ISR FAST Site

To: Nelson Chester, ISR Review Group Leader
From: Peter Levchenko, Manager, and Richard Breedon, Deputy Manager, ISR FAST Site
Subject: RE: Results of the ISR Readiness Review held on February 27, 2003

Appendix 1. ISR Organizational Chart

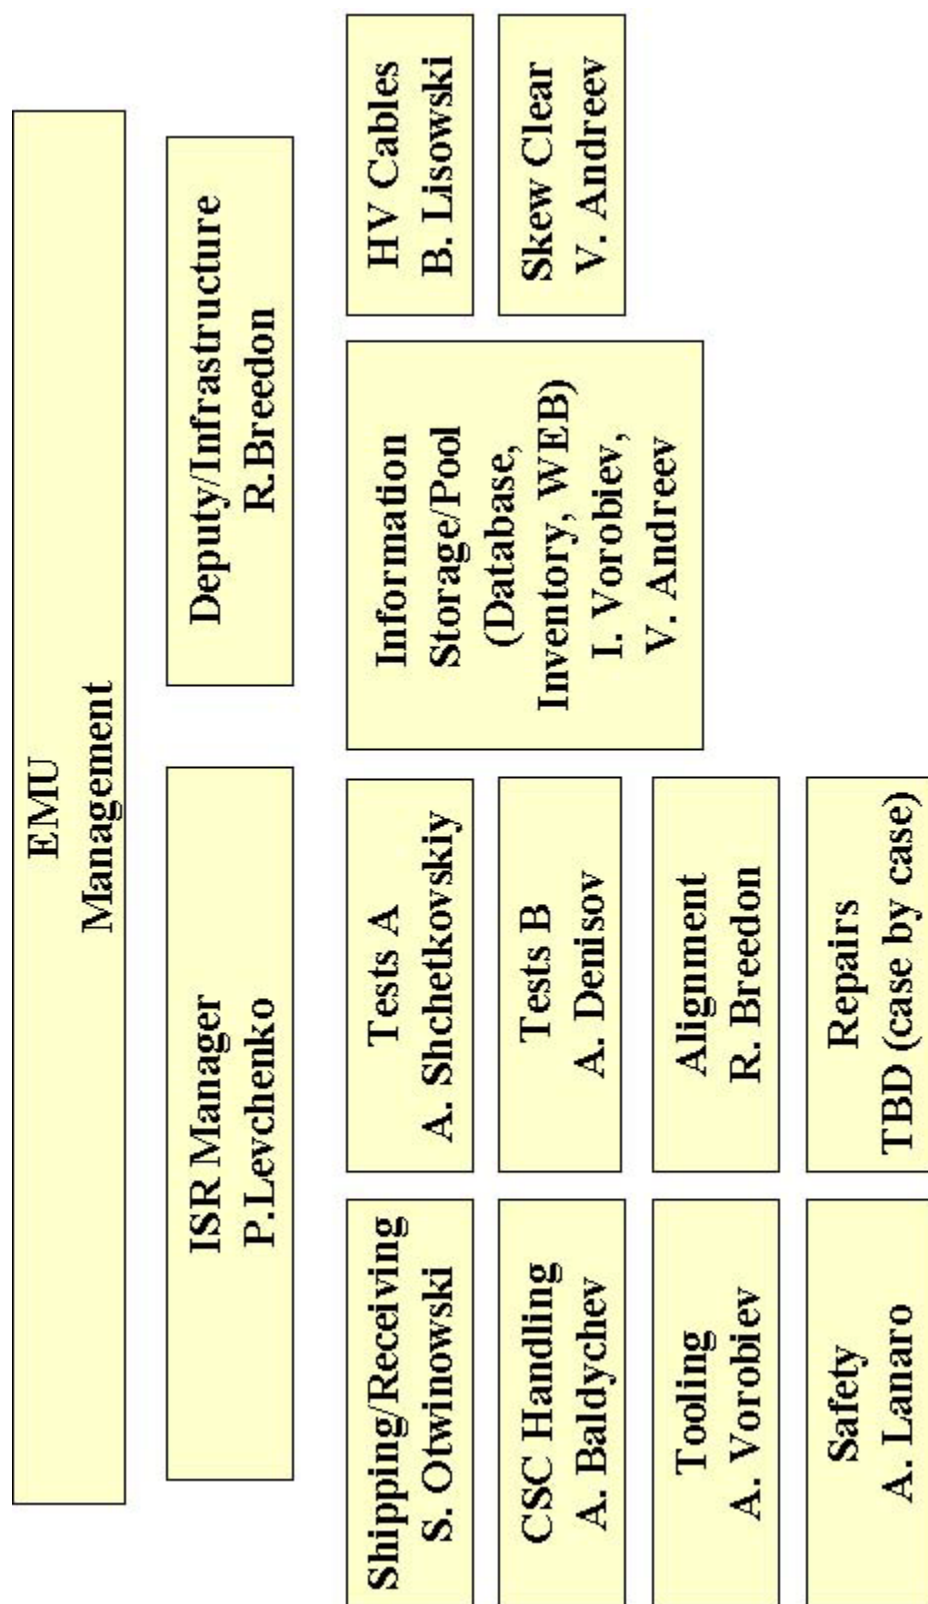
5. Peter and Richard are encouraged to refine the organization structure to eliminate to the extent possible the job overlap of many people doing many jobs, yet still preserving the cross training of individuals so that there is more than one trained person capable of doing any one job. Particularly for repairs and alignment plate installation, personnel who are trained and capable of performing these operations should be identified.

A copy of the updated ISR site organizational structure is included in Appendix 1 and is also available at <http://agenda.cern.ch/fullAgenda.php?ida=a03532> in the talk "ISR Status."

The observation of "job overlap" was made because of the repeated listing of the same names under different tasks. This was because these individuals perform preparatory work that is common to more than one task. Since the review, people at the site have carried out their tasks efficiently and on schedule with no noticeable job overlap. The procedures to follow for repairs and special tasks have been worked out and included in the instructions. People have been assigned to carry out these tasks. R. Breedon is responsible for alignment plate installation and is waiting for additional plates to be sent to CERN.
